**PLANNED UNIT DEVELOPMENT
& SUBDIVISION STAFF REPORT**

Date: April 5, 2007

DEVELOPMENT NAME Grande Oaks at Hillcrest Subdivision

LOCATION 2709 Hillcrest Road
(East side of Hillcrest Road, 340'± North of Shady Lane)

SITE PLAN

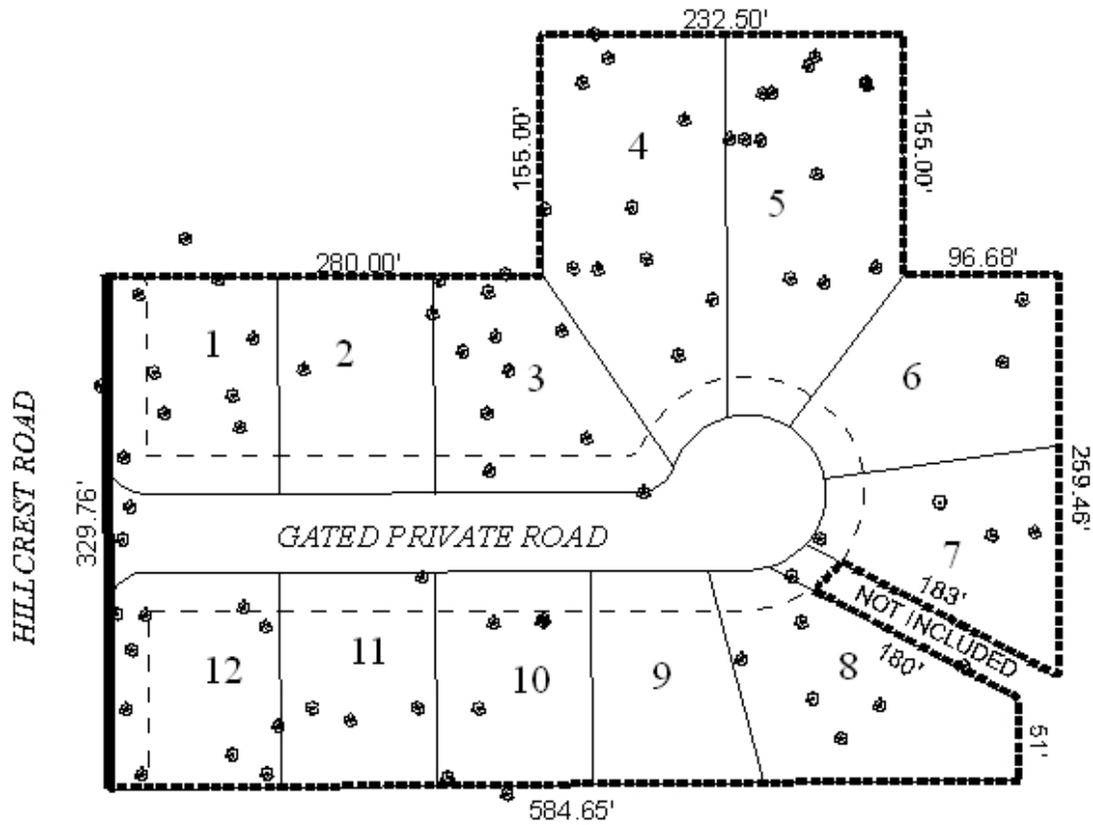
Preservation status is to be given to the 48” Live Oak Tree located on the South West corner of Lot 1, the 60” Live Oak Tree located on the South side of Lot 3, the 56” Live Oak Tree located on the South West corner of lot 3, the 76” Live Oak Tree located on the North East corner of Lot 6, and the 54” Live Oak Tree located on the West side of Lot 10. Any work on or under these

The site fronts Hillcrest Road, a planned major street with an adequate 100-foot right-of-way. As Hillcrest Road is a major street, access management is a concern. Proposed Lots 1 and 12 should be denied direct access onto Hillcrest Road. Also, the gate for the proposed private street may need to be moved further from Hillcrest so that traffic turning into the development will not stack-up into Hillcrest Road.

All of the lots appear to meet the minimum dimensional requirements of the Subdivision Regulations, however, the plat and PUD site plan should be revised to include the size of each lot in square feet as either a note on each lot, or as a table. It should be noted that there do not appear to be any requests by the applicant for reduced setbacks or increased site coverage, thus the standard requirements for R-1, Single-Family Residential districts will apply.

Finally, the PUD site plan and Subdivision plat do not depict any area set aside for detention. As PUD approval is site plan specific, and as the Subdivision plat may need to show any detention as common area, both the site plan and plat should be revised to depict a detention area for the development.

- 1) amending of the PUD application to include “Lot A of The Oaks” as part of the PUD application (including revised area information), and provision of additional labels and postage as necessary due to expanded notification requirements;
- 2) revision of the PUD site plan and Subdivision plat to depict a detention common area, if required; and
- 3) consultation with Traffic Engineering regarding the proposed gate, and revision of the PUD site plan and Subdivision plat to move the proposed gate further away from Hillcrest Road if determined necessary;

- 1) revision of the PUD site plan and Subdivision plat to depict a detention common area, if required; and
- 2) consultation with Traffic Engineering regarding the proposed gate, and revision of the PUD site plan and Subdivision plat to move the proposed gate further away from Hillcrest Road if determined necessary.
